# ENVIRONMENTAL BOARD AGENDA

**ENVIRONMENTAL BOARD  
ITEM 6A**

REQUEST: Lino Lakes Dealership & Offices CUP

CASE NUMBER: CUP2025-0001  
SBPR2025-0005

C1

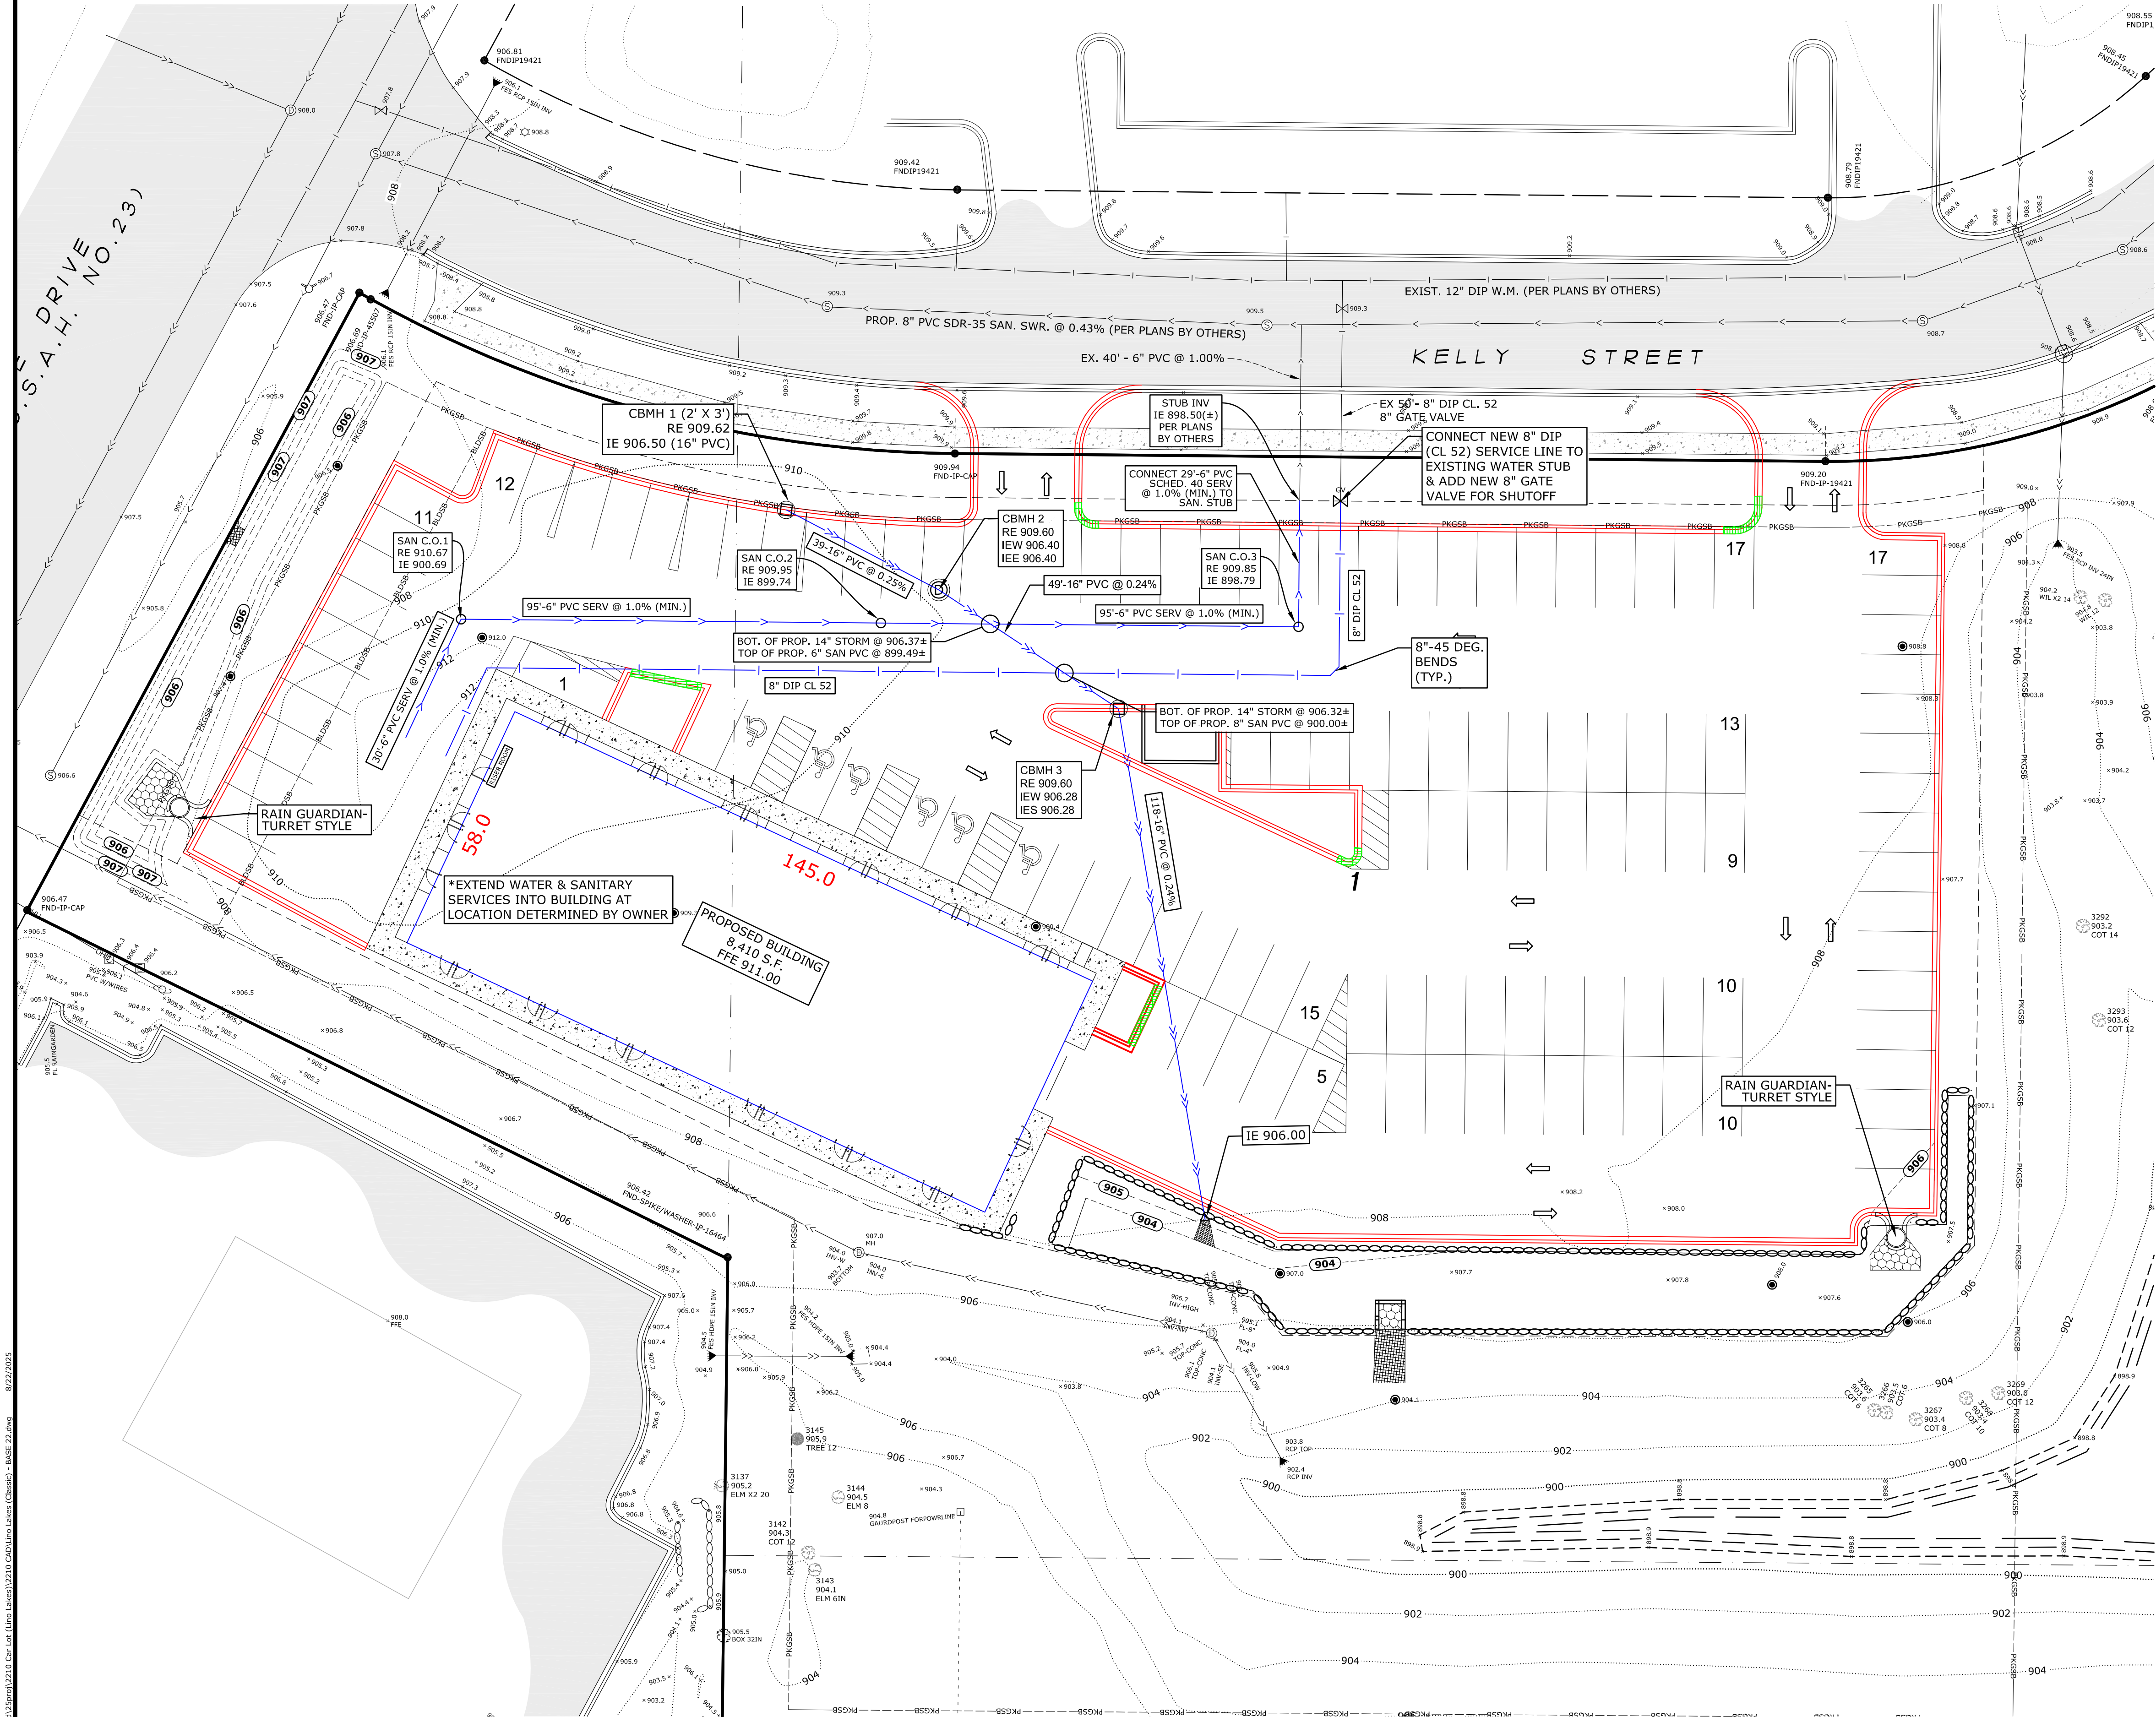
The plans show 25 shrubs meeting the requirements but only 2 large trees (4 medium trees) being proposed. Based on the design of the building with office frontage and doors to the sidewalk, additional tree planting is not feasible. City Code section 1007.049 4(d) states the city may allow flexible planting locations where service areas or other constraints make the standards difficult to meet. Staff believe this is the case in this situation.

- a. Plans call for a 64" fence, verify the final height and confirm it matches the detail provided.
8. NPDES permit will be required for the project. Provide proof of permit before construction.

- a. Provide inlet protection in both CB adjacent to Kelly Street
  - b. Add note that street sweeping of adjacent impervious surface is required by the authorization of the City Engineer.

### BAFFLE WEIR FOR INFILTRATION BASIN (INF-1)

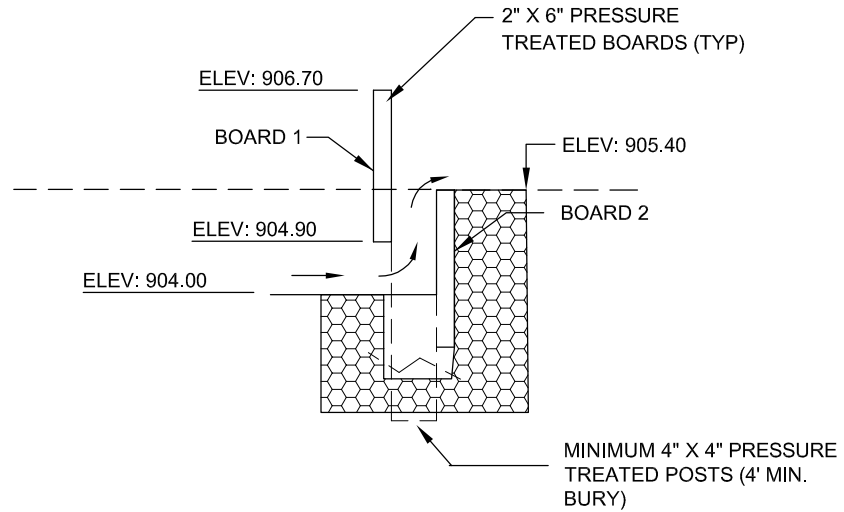
1. CBMH 3 should be a sump structure to provide pretreatment before discharging into the infiltration basin. Otherwise, an additional structure should be proposed prior to the outlet as a sump.
2. Recommend planting native species or low mow fescue adjacent to the parking lot where the site drains to the stormwater bmp.
  - a. Filtration of additional buffer will be beneficial to soil stabilization, pollutant filtration, and wildlife/pollinator habitat.
3. Rock mulch bed for landscaping to be flush with ground level.

4. Remove tree plantings from within the infiltration basin 1 as this will lead to maintenance issues.
5. Infiltration Basin 1 is being proposed as a snow storage area, staff highly recommends storing snow outside of the basin. Storage within the basin will lead to higher sedimentation rates, increased chloride, and maintenance issues.

6. Infiltration Basin 1 shows being stabilized with sod, provide live plugs and native seed like Basin 2.
7. Plans show a 5' fence between the commercial and residential for screening.

TREE INVENTORY & PRESERVATION PLAN

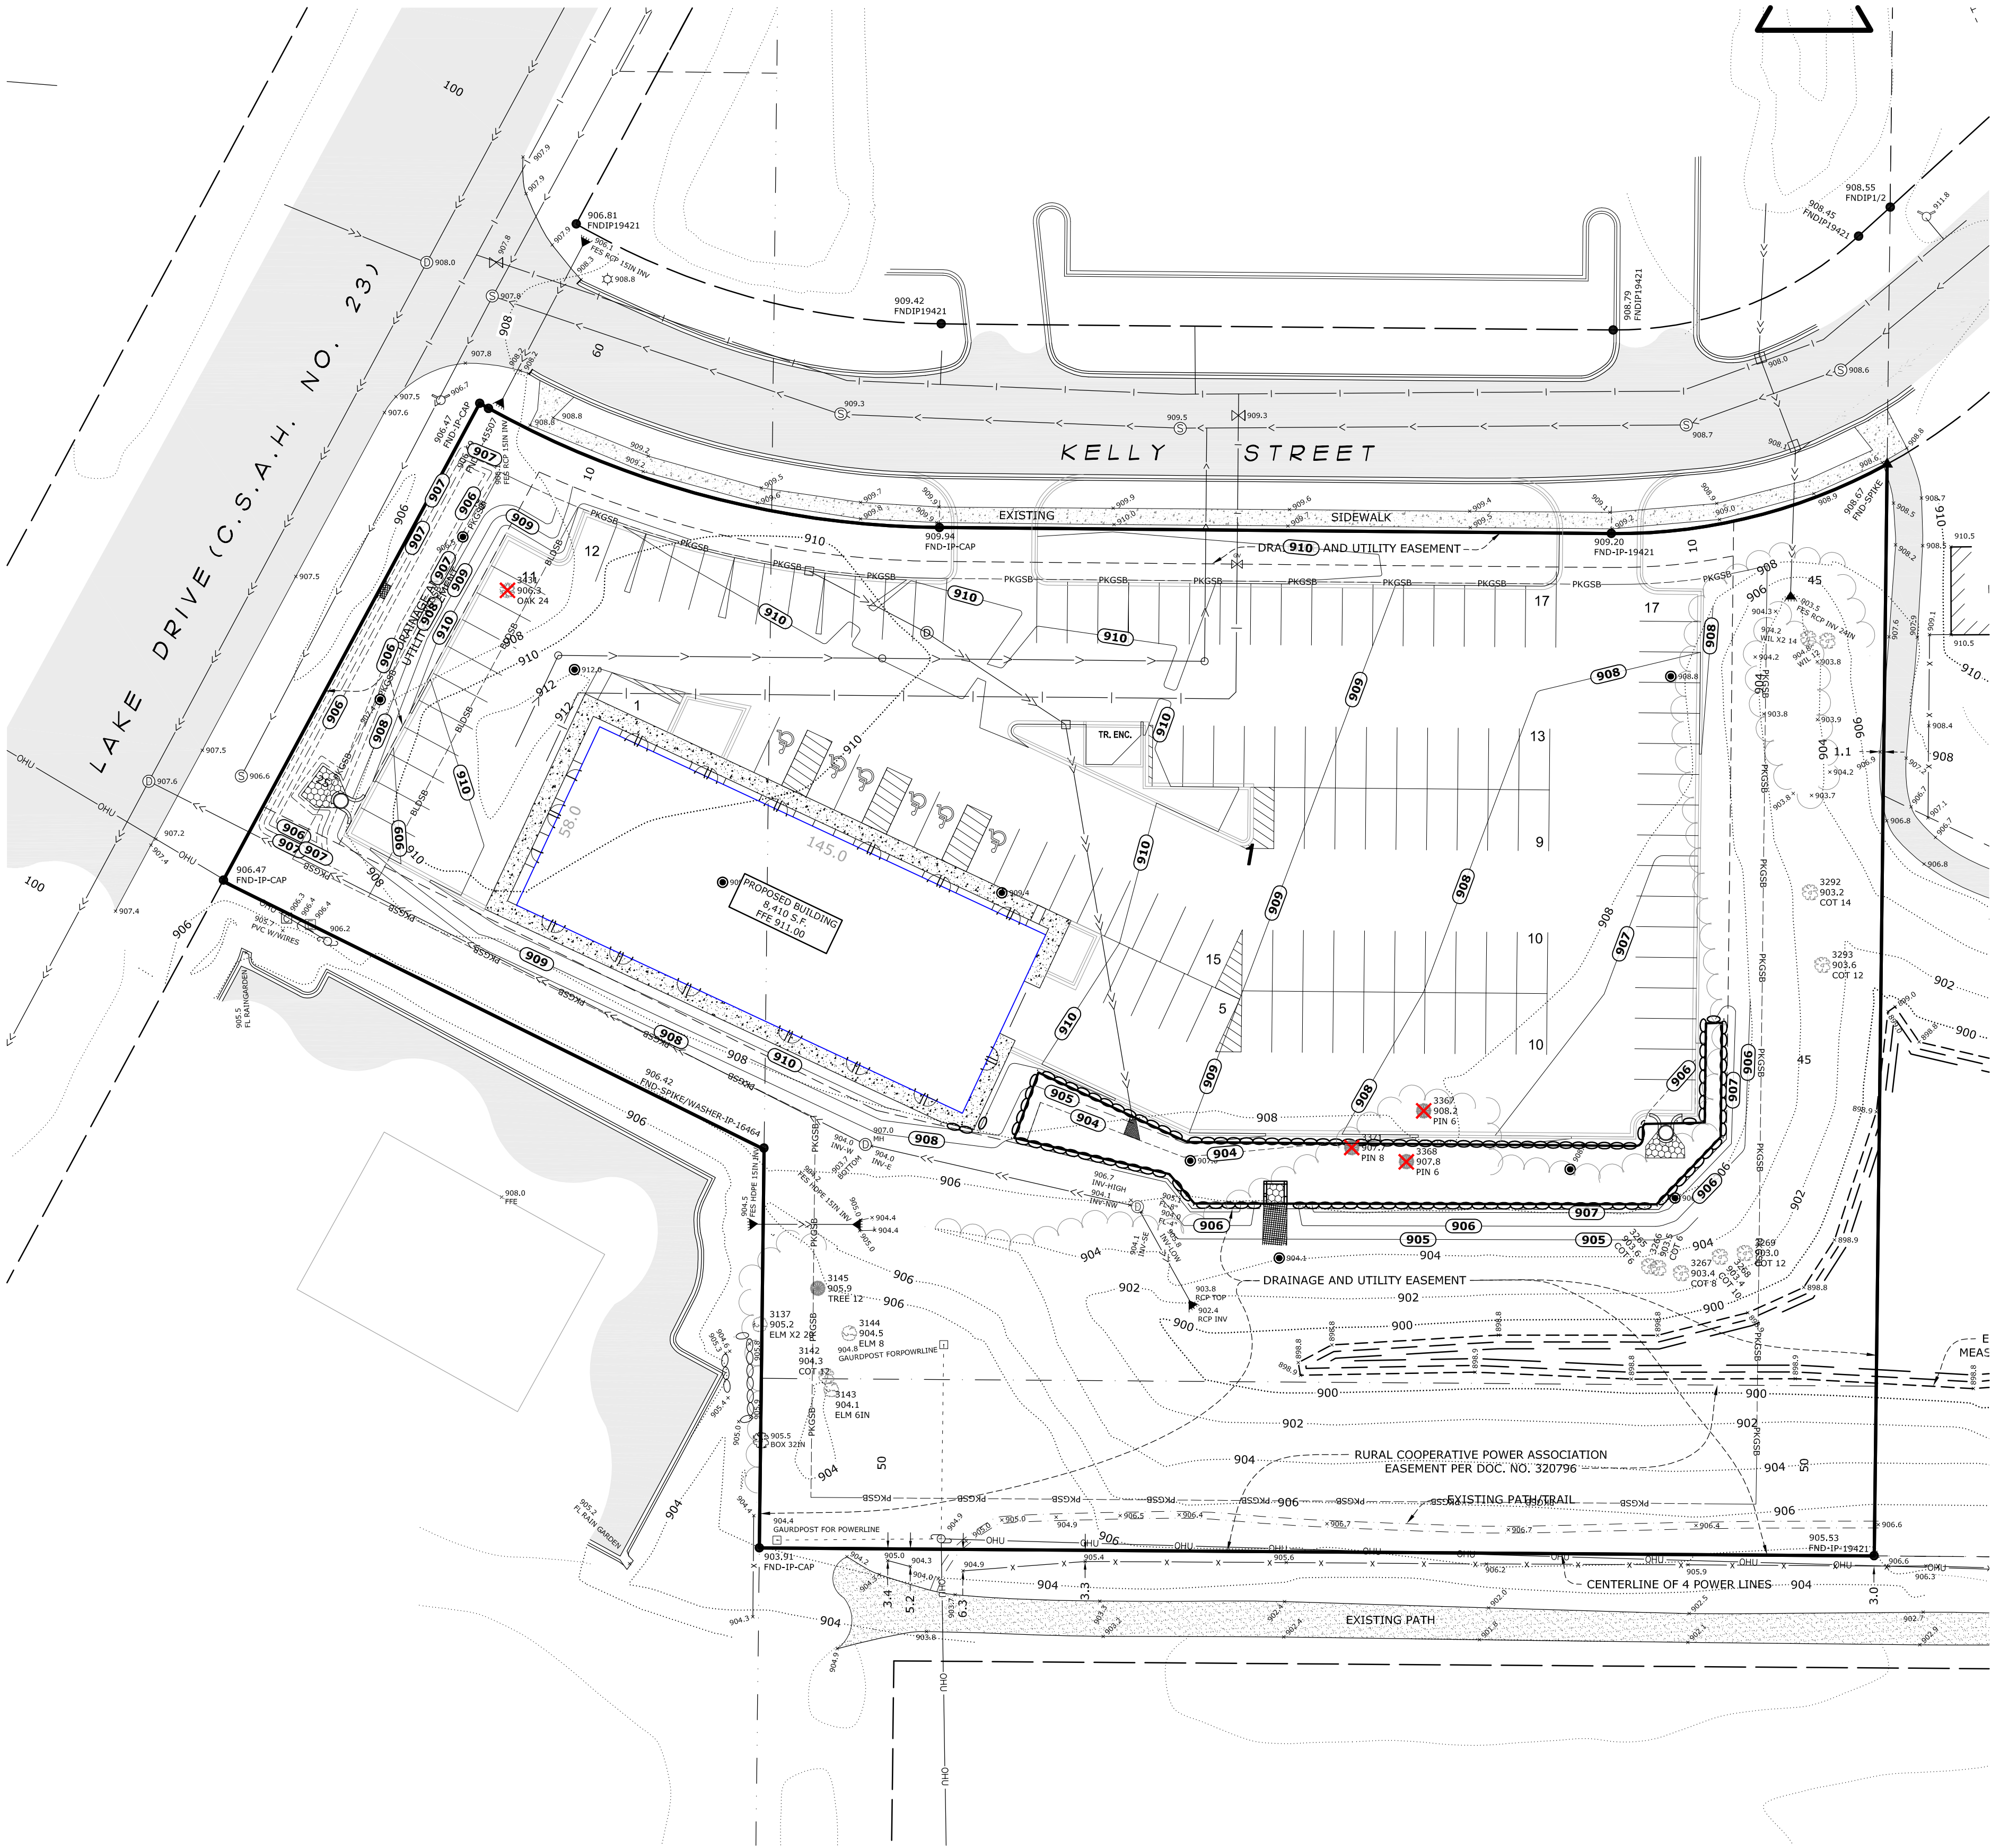
A tree preservation plan was required for this project. There are 17 existing onsite trees, as part of the project 4 will be removed. The 4 trees to be removed are within the Basic Use Area and do not require replacement.
